# Ethernet Routing Switch

## 8300

### Software Release 3.0.x.x

### Software Release 3.0.4.0

Note: Here is a example for the diamond SMLT topology

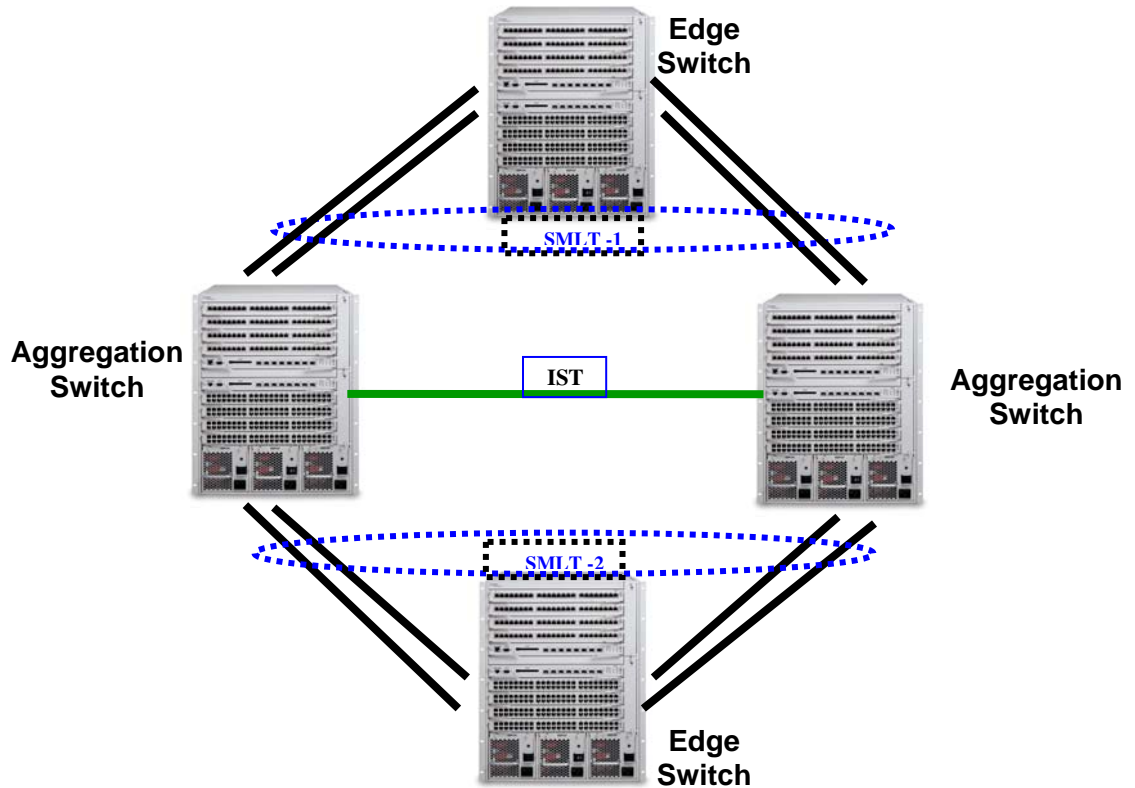
In a diamond SMLT topology consisting of 4 ERS8300 devices, the booting with factory default configuration of the edge switch now doesn't cause the system instability of the aggregation switch. (Q01475259)
